UNITED STATES PATENT AND TRADEMARK OFFICE

10/774,264

Office Action Summary

DETAILED ACTION

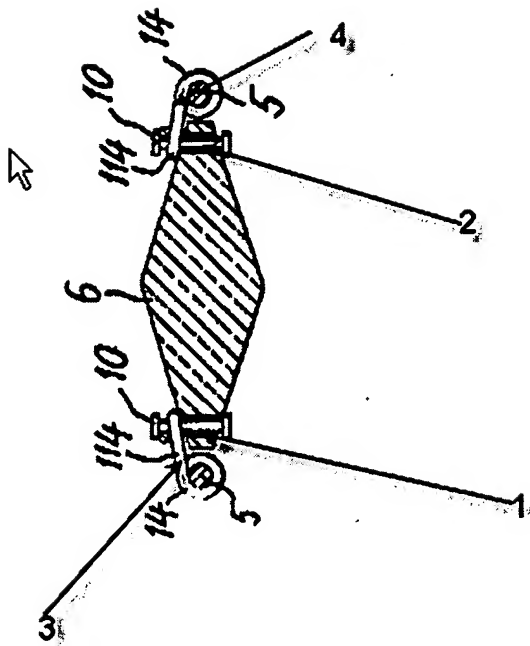
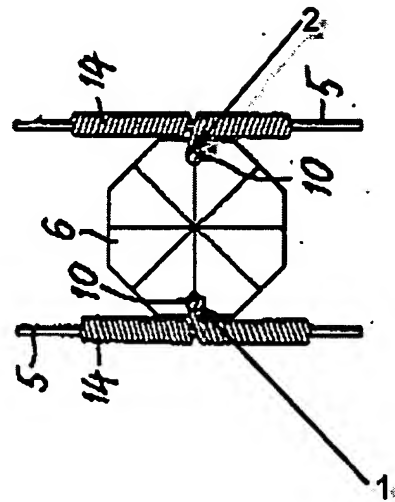
As for Claim 1, EP 0200924 teaches of a arrangement/link construction for a crystal pendant, the arrangement (Fig. 11, see figures below) comprising:

- a first ornament (6) having at most a first aperture (1) and a second aperture (2);
- a second ornament (above or below 6) having at most a first aperture (1) and a second aperture (2); and

- a first connector wire (page 11, line 5, "...a wire 14 is helically wound around each lateral rod 5...") (left 14) having a first end (3) [adapted to be] mounted to the first aperture (1) of the first ornament (6) and a second end (the end attached to the ornament above or below) adapted to be mounted to the first aperture (1) of the second ornament (above or below 6); and

- a second connector wire (page 11, line 5, "...a wire 14 is helically wound around each lateral rod 5...") (right 14) having a first end (4) [adapted to be] mounted to the second aperture (2) of the first ornament (6) and a second end (the end attached to the ornament above or below) [adapted to be] mounted to the second aperture (2) of the second ornament (above or below 6).

whereby the second aperture (2) of the first ornament (6) is laterally disposed from the first aperture (1) of the first ornament (6).

Re: Claim 3, wherein the second aperture (2) of the second ornament (above or below 6) is laterally disposed from the first aperture (1) of the second ornament (above or below 6).

Re: Claim 4, wherein the second aperture (2) of the first ornament (6) is opposite the first aperture (1) of the first ornament (6).

Re: Claim 9, further comprising at least a third ornament (two above or below 6) having at least one aperture (1) and at least one third connector (14 from the second ornament to the third ornament) connecting the second ornament (above or below 6) and the third ornament (two above or below 6).

Re: Claim 12, wherein the decorative ornaments (6) comprises one or more of beads, crystals, stones, and gems (6).

Re: Claim 13, wherein at least the first connector (14) comprises a metallic wire having a diameter between about .0625 inches and about .125 inches.

Re: Claim 14, wherein the first ornament (6) and the second ornament (6) comprise octagonal ornaments (6).

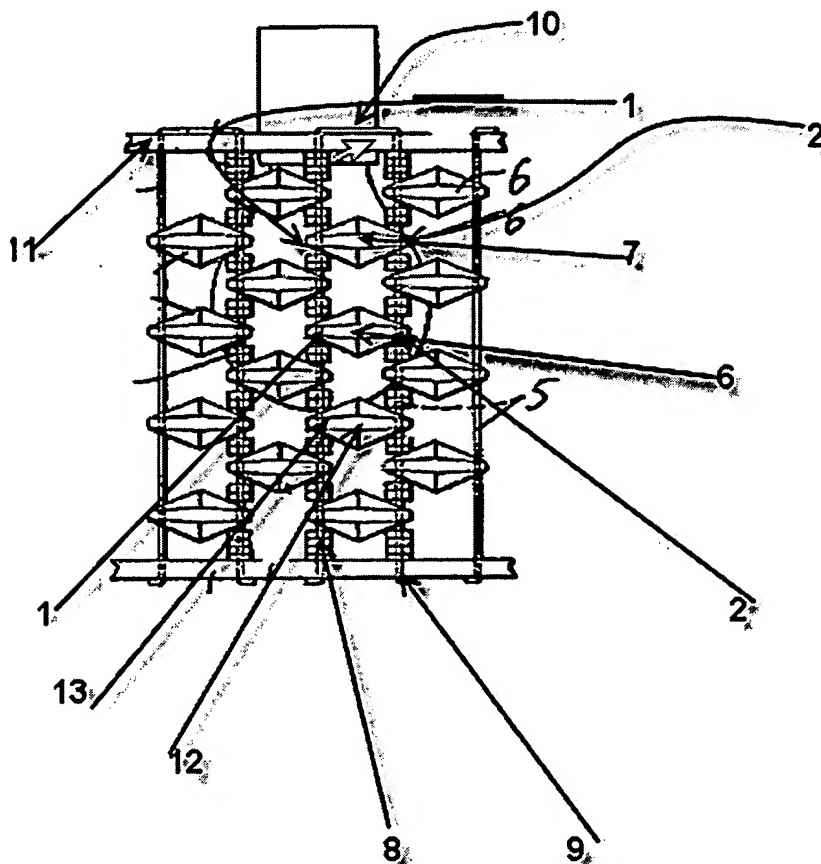
[7] As for Claim 1, EP 0200924 teaches of a arrangement/link construction for a crystal pendant, the arrangement (Fig. 23, see figure below) comprising:

a first ornament (6) having at most a first aperture (1) and a second aperture (2);
a second ornament (7) having at most a first aperture (1) and a second aperture (2); and
a first connector wire (8) (page 14, line 23, "...of a generally metallic wire forming...")
having a first end [adapted to be] mounted to the first aperture (1) of the first ornament (6) and a
second end [adapted to be] mounted to the first aperture (1) of the second ornament (7); and

a second connector wire (9) (page 14, line 23, "...of a generally metallic wire forming...") having a first end [adapted to be] mounted to the second aperture (2) of the first ornament (6) and a second end adapted to be mounted to the second aperture (2) of the second ornament (7).

whereby the second aperture (2) of the first ornament (6) is laterally disposed from the first aperture (1) of the first ornament (6).

Re: Claim 3, wherein the second aperture (2) of the second ornament (7) is laterally disposed from the first aperture (1) of the second ornament (7).

Re: Claim 4, wherein the second aperture (2) of the first ornament (6) is opposite the first aperture (1) of the first ornament (6).

Re: Claim 10, wherein at least the first connector (8) comprises at least one-pre-formed U-shaped wire connector (10) having ends adapted to be inserted into and secured to an aperture of an ornament (6).

As for Claim 23, EP 0200924 teaches of a arrangement/link construction for a crystal pendant, the arrangement (Fig. 23, see figure above) comprising:

at least one ornament (6 or 7) having a first aperture (1) and a second aperture (2); and

at least one hook (10) having a first end (8) adapted to be inserted and secured to the first aperture (1) of the ornament (6 or 7), a second end (9) adapted to be inserted and secured to the second aperture (2) of the ornament (6 or 7), and a loop (below 10) positioned between the first end (8) and the second end (9), the loop (below 10) [adapted to be] hung from a support (11);

wherein, when hung by the loop (below 10), the second aperture (2) of the ornament (6 or 7) is laterally disposed from the first aperture (1) of the ornament (6 or 7).

As for Claim 54, EP 0200924 teaches of an arrangement for connecting decorative ornaments the arrangement (Fig. 23, see figure above) comprising:

- a first ornament (6) having at most a first aperture (1) and a second aperture (2);
- a second ornament (7) having at least a first aperture (1);
- at least a third ornament (12) having at least one aperture (13); and
- at least one continuous connector (8) passing through an aperture of at least the first ornament (6), the second ornament (7), and the third ornament (12), and wherein the continuous connector (8) comprises means to engage and secure the first ornament (6), the second ornament (7), and the third ornament (12) in spaced relationship with each other;

whereby the second aperture (2) of the first ornament (6) is laterally disposed from the first aperture (1) of the first ornament (6).

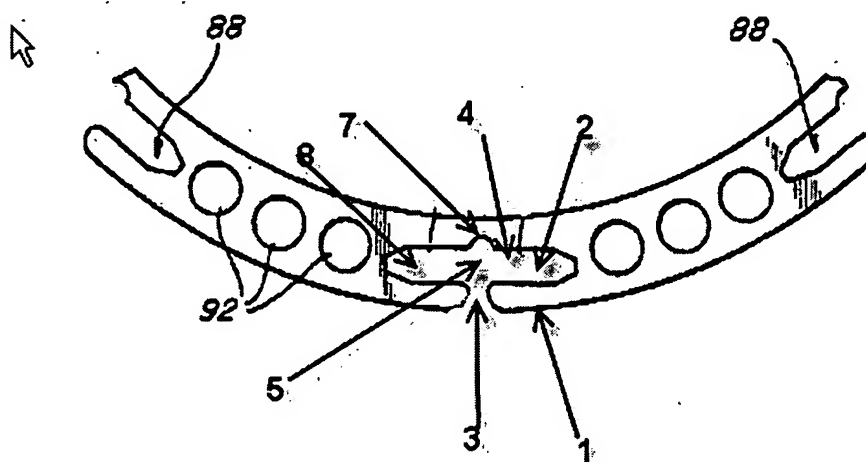
As for Claim 29, Schonbek teaches of a gallery assembly for chandeliers, the device comprising (See Figure below):

a plate having an outer edge (1); and

a channel in the plate (2) having an open first end (3) located at the edge of the plate (1), a closed second end (4), the channel (2) comprising a horizontal passage (2) and at least one vertical passage (6) located between the open first end (3) and the closed second end (4);

wherein the channel (2) [is adapted to] receive the hook (82) of the ornament (76) and support the hook (82) in the closed second end of the channel (Fig. 8 of Schonbek).

Re: Claim 30, wherein the channel (28) further comprises an expansion (7) in the vertical passage (6).

Re: Claim 31, wherein the closed second end (4) comprises a convergent closed second end (7).

Re: Claim 32, wherein the convergent closed end (7) converges to a point (7).

Re: Claim 33, wherein the channel (2) comprises a channel (3) that passes through the thickness of the plate.

Re: Claim 34, wherein the at least one vertical passage (6) of the channel (2) comprises at least two vertical passages (6, 8).

a channel (2) in the plate having an open first end (3) located at the edge of the plate (1), a closed second end (4), comprising a horizontal passage (2) and at least one vertical passage (6) located between the open first end (3) and the closed second end (4);

wherein the channel (2) [is adapted to] receive the hook (82) of the ornament (76) and support the ornament (76) whereby the preferred direction of orientation of the ornament (76) is directed substantially parallel to the planar surface of the plate (Fig. 8).

[13] Applicant's arguments filed 1/6/2006 regarding rejections under 35 U.S.C. 102 with regard to Schonbek (Claims 29-38, 60-62) have been fully considered but are not persuasive. In response, the examiner would like to direct the applicant's attention to the figure provided from Schonbek (see above) that better illustrates the anticipatory features of Schonbek with regard to the instant claimed invention.
